In the Matter of)
) Docket 50-344
PORTLAND GENERAL ELECTRIC COMPANY,)
et al) (Control Building Proceeding)
)
(Trojan Nuclear Plant))

LICENSEE'S RESPONSE TO EUGENE ROSOLIE AND
COALITION FOR SAFE POWER'S FIRST SET OF
INTERROGATORIES TO LICENSEE, PHASE II, DATED JUNE 30, 1979

**CONTROL BUILDING FLOOR PLAN EL 93'-0"
SHOWING EXISTING AND NEW SHEAR WALLS**

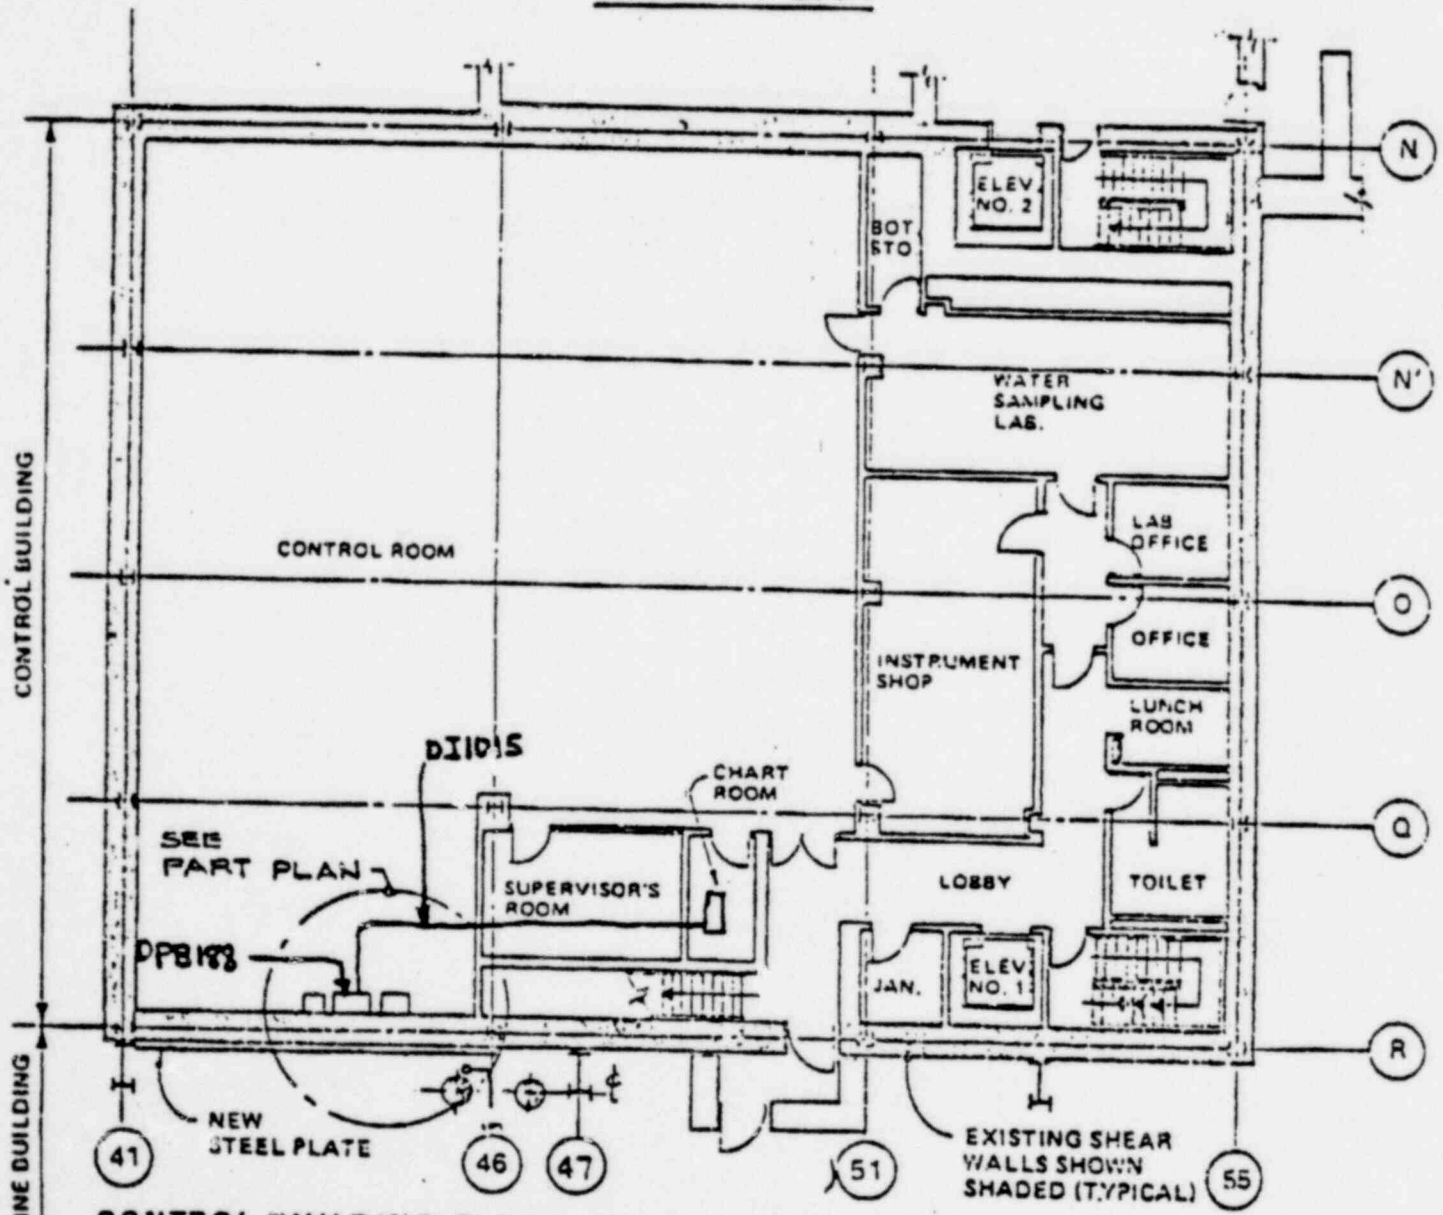
"Give the location, equipment served, technical specifications and how affected by modification work for the following cables: DBP-188, DI-1015, BB-1142, AB-1080, BRA-747, AB-1010, and BB-1137"

The referenced items are not cables, but rather are conduits, a pull box and a cable tray. Safety-related cables within such items do not consist of both Train "A" and "B" for any piece of equipment served. Conduit DI 1015 and pull box DBP-188 contain cables from safety train "B" and are located at Elevation 93 ft of the Control Building, as illustrated in the attached Sketch No. 1. Conduit AB-1010

Sketch Nos. 1 and 2 can be compared with the figures in Section 3 of PGE-1020 to see the modification work in these areas which includes: drilling; installation of bolts, plates, washers and nuts; and for Sketch No. 2, some forming and placement of concrete in the opening through the east wall.

Protection of the conduits and cable trays is described in Section 4 of PGE-1020, answers to NRC Staff questions, and responses to your Interrogatory 7. (DLD)
